Agenda Item #2

Application 2024-21-CA

960 Dauphin Street

Replace damaged/missing siding. Replace windows and some doors. Repair existing porches, including installing new railing on second-floor porch. Complete porch and deck on east elevation. Repaint.

B NEW ELEVATION
SCALE: 1/4" = 1'-0"

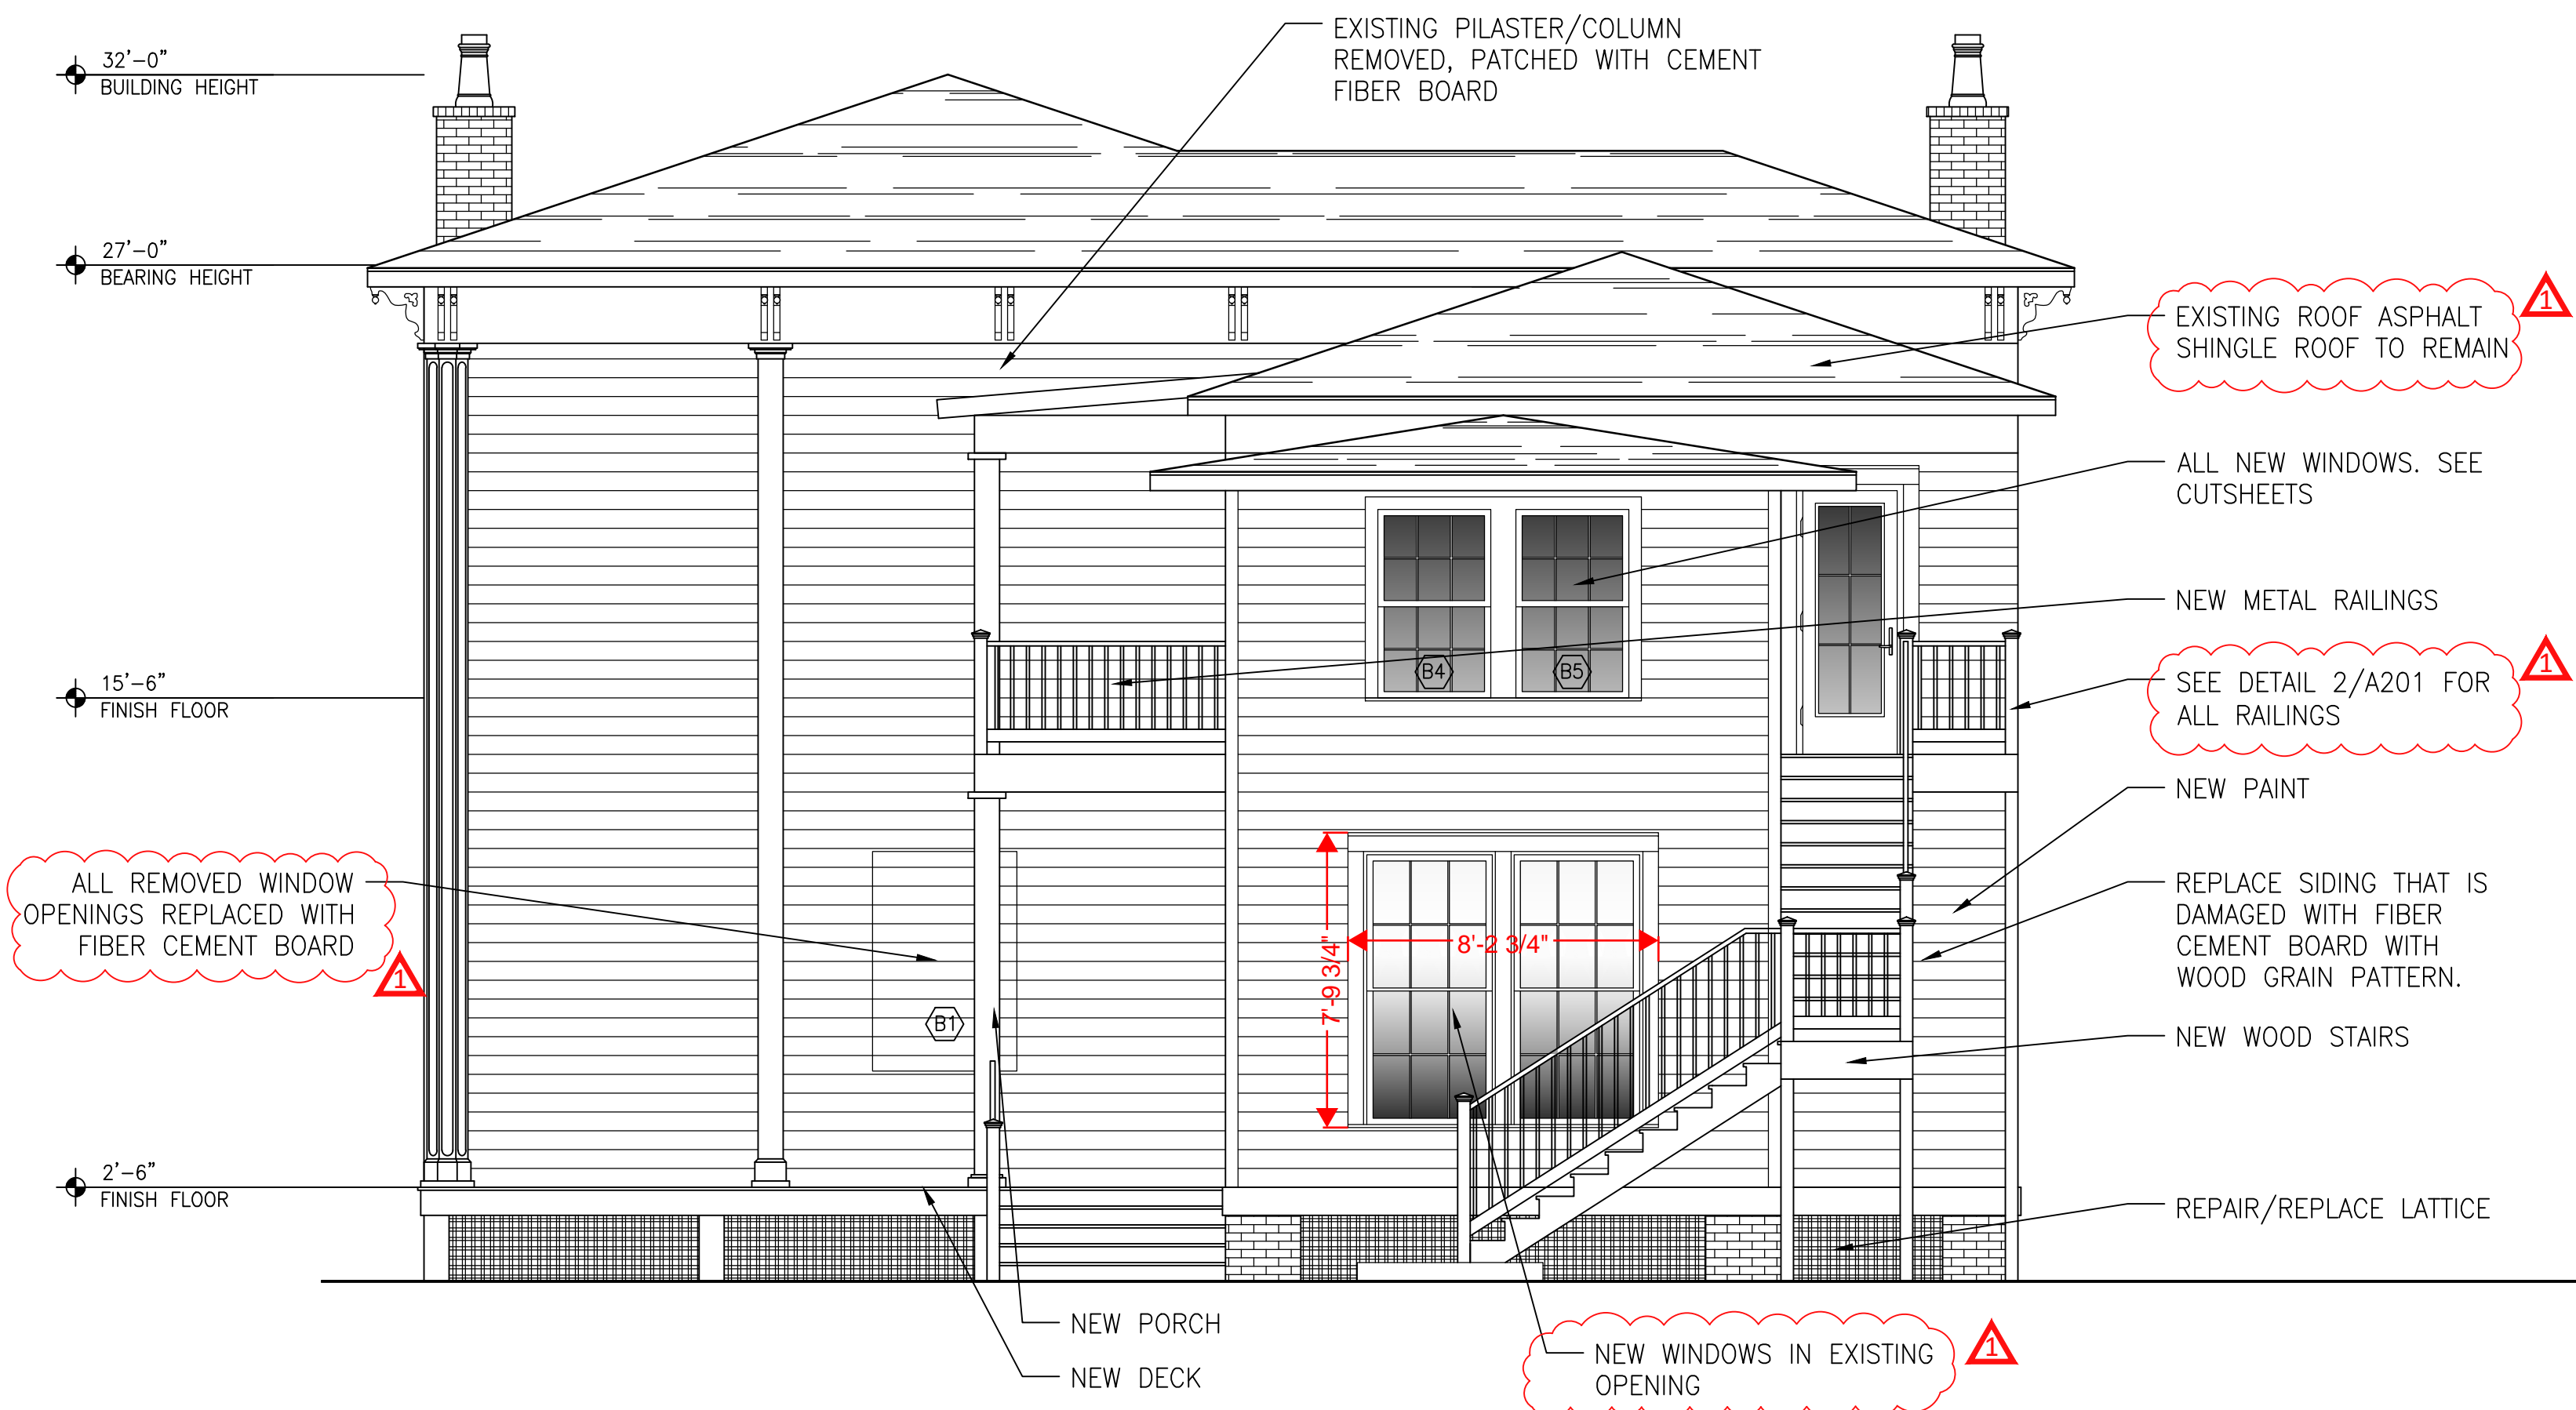
The *Guidelines* call for a new porch to be compatible with the neighborhood in placement, proportion, rhythm, materials, and ornamentation. (6.9, 6.11, 6.13) The Guidelines further stipulate that a rear or side porch that is visible from the public right-of-way should be subordinate in character to the front porch. (6.9) The proposed side porch would be located in the same location of a non-extant porch structure shown on Sanborn maps dating back to 1904. The porch would be lower in height than the front porch, in appropriate proportion to the rear service wing, which has a lower roof ridge height than the main dwelling. The proposed 8" square wood columns are appropriately less ornamented than the elaborately fluted octagonal columns of the main porch while still echoing the more simply detailed rectangular pilasters on the side and rear elevations.

The tripartite configuration of the porch represents a departure from the temple-front-with-side-wing form of the original dwelling. The four double-height columns across the three central bays are similar in scale to the monumental front porch columns and simpler double-height columns still visible on the north elevation where a historic porch has been infilled. However, the single-height columns at either end of the proposed porch create two diminutive side wings that are not in keeping with the proportions of the original structure and are not typical of the original period of construction. Second-story gallery porches of this period typically remain the same height across the entire elevation, without the step down created at either end where the proposed porch roof does not extend fully across the second-floor porch deck.

The proposed porch utilizes a mix of materials, some of which replicate the existing construction materials of the historic property and some of which do not. The porch columns, deck, and railing end posts are all painted wood, which is the predominant materials used in the historic front porch. However, the proposed metal roof and metal railings are not part of the existing material palette at 960 Dauphin. Existing railings on the historic front porch are simple wood pickets, which the application proposes replacing with new metal railings. While this would create harmony between the new and historic porch structures, the *Guidelines* caution against replacing historic materials with unlike materials, especially on primary facades (5.6). While metal roofing is not found elsewhere at 960 Dauphin, there is precedent for employing a more utilitarian material, such as metal roofing, on secondary structures such as side or rear porches on dwellings of this period and style.

Submitted plans propose installation of eight pairs of French doors leading onto the new two-story porch: five on the first floor and three on the second. On the first floor, each set of doors would feature a 4-lite transom. French doors are not typical of dwellings of this style and period, and the addition of so many side-by-side creates a higher ratio of voids to solid surfaces than seen currently at the subject property. While the proportions are not in keeping with the period and style of the dwelling, the materials – aluminum-clad wood and simulated divided lites with spacer bars – are in keeping with the *Guidelines*.
